INITIAL FIRE SAFETY INSPECTION REPORT

KC Apparels Limited

RSC ID: 24991

Date: 11-Jun-2024

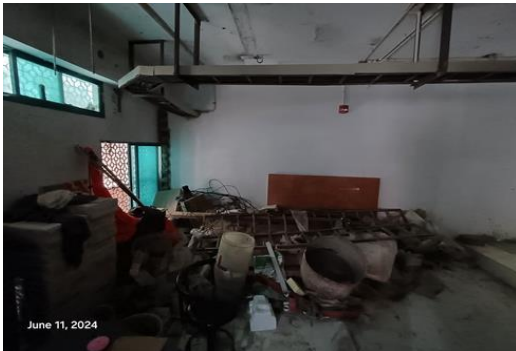
SI No.	Category	Findings	Required Action	Remediation Time Frame
F-3	Fire Rated Construction	<p>At ground floor, high hazard occupancies like storage room, generator room etc. directly discharge to exit stair enclosure without vestibules.</p> <p>Location: North and South Stair Enclosure at Ground floor of main building-1</p>	<p>Openings from exit enclosure to storage and machine room spaces shall be provided with a vestibule with fire rated construction and openings. Provide a 1.5- hr. fire rated door on the exit stair side and a 0.75- hr. fire rated door on the storage and machine room side. Ensure that the fire rating of the vestibule construction matches that of the exit stair enclosure. The minimum width for vestibules shall not be less than 1.1m and length 1.8m.</p>	Within 3 Months

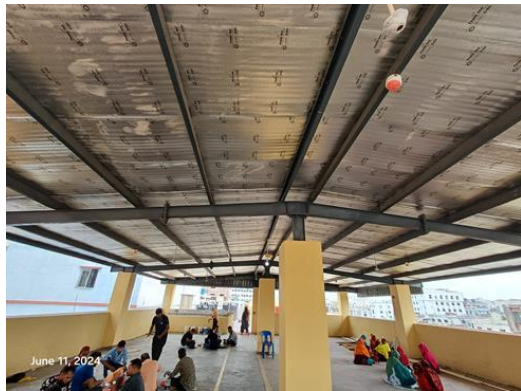
SI No.	Category	Findings	Required Action	Remediation Time Frame
F-8	Fire Rated Construction	The main structural element (column, Bracing, rafter etc.) of Dining shed located at occupied roof of Main production building (High rise building) are constructed by steel without providing any fire resistance rating assemblies. Exterior wall is also not fully constructed with required fire resistance rating where other occupancies/ building very close to shed.	<p>The High-rise building shall be type-I construction as per RSC Technical Guidelines (Standard) 3.5.2 & 3.6.2. Provide required rating in the structural elements of the building. Proximity between group of occupancies and exterior wall rating shall be ensured according to BNBC 2006 Part 3 Table 3.2.2. Consult with a qualified fire protection engineer.</p> <p>Submit the proposed drawing/design to RSC for review. Once reviewed, install passive fire protection as per reviewed design.</p>	Within 6 Months

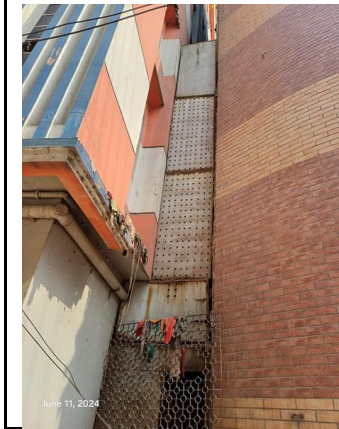
SI No.	Category	Findings	Required Action	Remediation Time Frame
F-9	Fire Rated Construction	<p>Another RMG building of different owner is located at approximately 3'-6" feet distance from RCC building-1 in south side. There are non-rated openings (windows/ high windows/ exhaust fan) at all floor level for both the buildings. Openings of building-1 which are within 10 ft distance from openings of other owners building are not provided with required fire resistance rating.</p>	<p>Exterior wall rating shall be ensured according to BNBC 2006 Part 3 Table 3.2.2 and Table 3.3.1. Consult with a qualified fire protection engineer. Either, seal the non-rated openings of building-1 which are within 10 ft distance from openings of other owner building by 3 hour rated construction assemblies.</p> <p>Or, Replace non-rated openings of building-1 by 3-hr fire-rated listed/certified assemblies glass assemblies/ louvers/dampers etc. The installation of such fire-rated assemblies shall be following certified design and manufacturer's guidelines.</p>	Within 6 Months

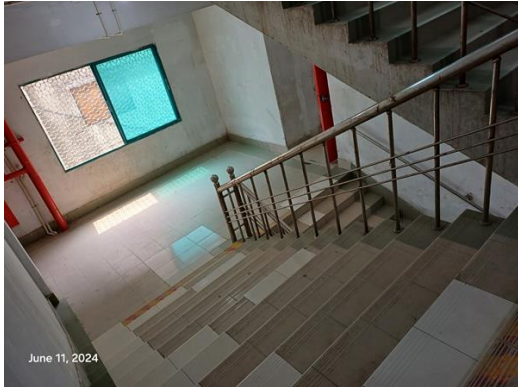
SI No.	Category	Findings	Required Action	Remediation Time Frame
F-15	Means of Egress	In each floor one flight out of two flight of stair, handrails are not provided on both sides of the north and south exit stair.	Provide handrails on both sides of the exit stair throughout all flights on all floors. Intermediate handrails shall be provided when the stair width exceeds 2.2 m (87 in.)	Within 1 Month

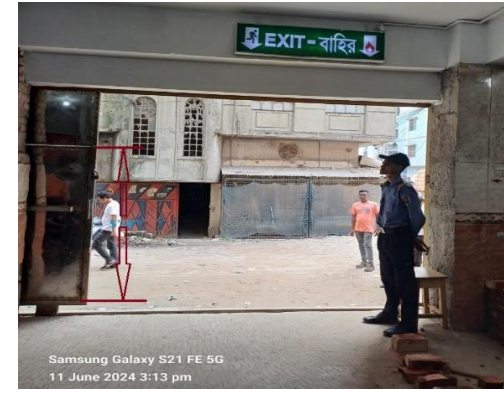
SI No.	Category	Findings	Required Action	Remediation Time Frame
F-17	Means of Egress	Height of south final exit is 4'-7" as it is obstructed at bottom. Height of north final exit is 5'-4". Both the final exit height is less than the minimum height requirement of door in a means egress	Provide doors in a means of egress having a minimum height of 2.0 m (79 in.).	Immediate

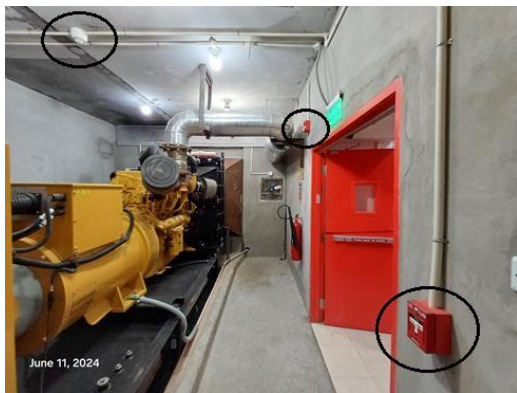
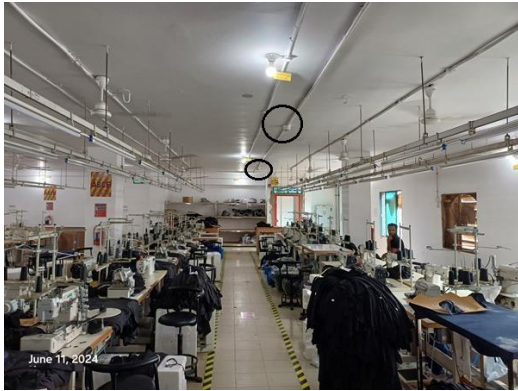
SI No.	Category	Findings	Required Action	Remediation Time Frame
F-23	Fire Alarm & Detection System (FADS)	<p>Fire alarm and detection system installation work is on-going. At 3rd and 4th floor, without defining the occupancy installation work is ongoing. Proposed design is not found during the inspection. After completion of installation as-built FADS system requires detailed review to confirm compliance with NFPA 72 and RSC Technical Guidelines (Standard).</p> <p>Location: All floors of RCC building-1</p>	<p>Install the fire detection and alarm system throughout the building in accordance with RSC Technical Guidelines (Standard) and NFPA 72. Complete the fire alarm installation as per NFPA 72.</p> <p>After installation the owner shall conduct internal testing and commissioning and then contact the RSC for witness of final acceptance testing. Submit as-built drawings, testing records, equipment certification and other relevant documentation to the RSC for review and approval. Modification (if required) shall have to done as per the reviewed design and NFPA- 72. Upon approval & modification (if required) the factory shall inform RSC to conduct final testing and commissioning verification of the system for final acceptance.</p>	<p>Design within 2 Months, installation/modification on within 4 Months</p>

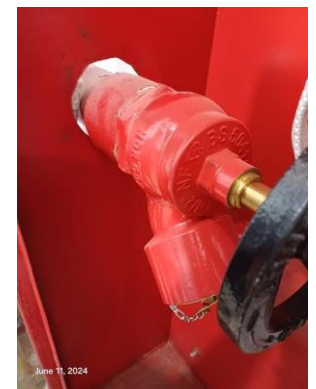
SI No.	Category	Findings	Required Action	Remediation Time Frame
F-24	ITM FADS	Inspection, testing and maintenance for the fire detection and alarm system was not in accordance with standard.	Inspect, test and maintain the fire alarm system and keep written records on-site, in accordance with Table-14.3.1 of NFPA 72.	1 Month after installation
F-25	Fire Protection System	<p>Installation work of the required standpipe system is on-going. Proposed drawing is not found during the visit.</p> <p>Standpipe installation requires detailed review to confirm compliance with NFPA 14, 20 and RSC standards.</p> <p>Location: All floors of RCC building-1</p>	<p>Install a standpipe system in accordance with RSC standard 5.4 and NFPA 14. A class III system shall be installed in buildings with the highest occupiable floor 10 m (33 ft.) above grade or more. A class I system shall be permitted in buildings protected throughout by an approved automatic sprinkler system.</p> <p>Submit the as-built standpipe system drawing to RSC for review. Once reviewed, install or modify the standpipe system throughout the building in accordance with RSC standard and NFPA 14,20,22 and 24. After installation the owner shall contact the RSC for witness of conducting the final acceptance testing of the standpipe system.</p>	Design within 2 Months, installation/modification on within 4 Months
